Office Action Summary	Application No. 10/646,643	Applicant(s) DAILEY, GEORGE WILLIAM	
	Examiner Timothy M. Ayres	Art Unit 3637

DETAILED ACTION

This is a first office action on the merits of application SN10/646,643.

King '090 Fig. 1

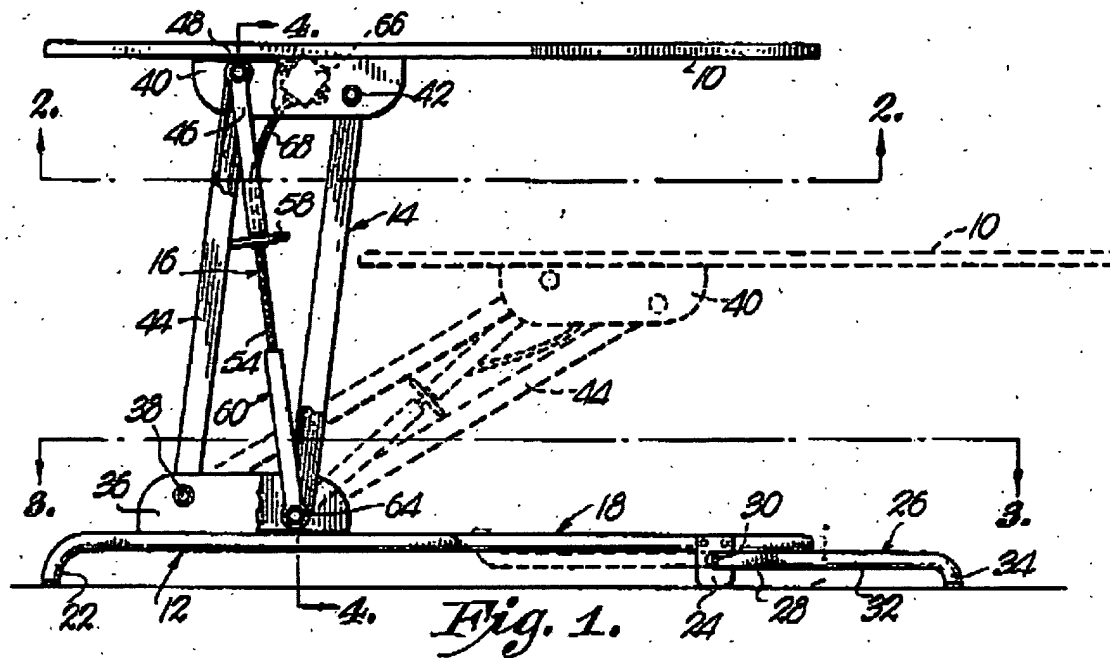
8. Claims 1-4 and 8 are rejected under 35 U.S.C. 102(b) as being clearly anticipated by U.S. Patent 3,288,090 to King. King '090 discloses an elongated

planar member (10) that has a top and bottom side and inherently can support a patient. A support assembly (12) includes a base (18) that defines the base plane and a pedestal (36) disposed on the base (18). A plurality of elongated connecting arms (14), with a first end defined by pins (42) and a second end defined by pins (38). The first end of the elongated members (14) is pivotally attached through pins (42) to the bottom of the planar member (10) through flange (40). The second end of the elongated members (14) is pivotally attached through pins (38) to the base pedestal (36). The planar member (10) moves from a first position to a second position as shown in figure 1 with the elongated members (14) traveling through an axis that is orthogonal to the base.

9. The means for moving the planar member from the first position to the second position is a motor assembly (66, 68) with a screw member (54), which connects to the pins (38,42) and the connecting arms. The plane of the first position and the plane of the second position are parallel to each other and the base plane as shown in figure 1. The plurality of elongated members (14) is arranged in a four bar linkage.
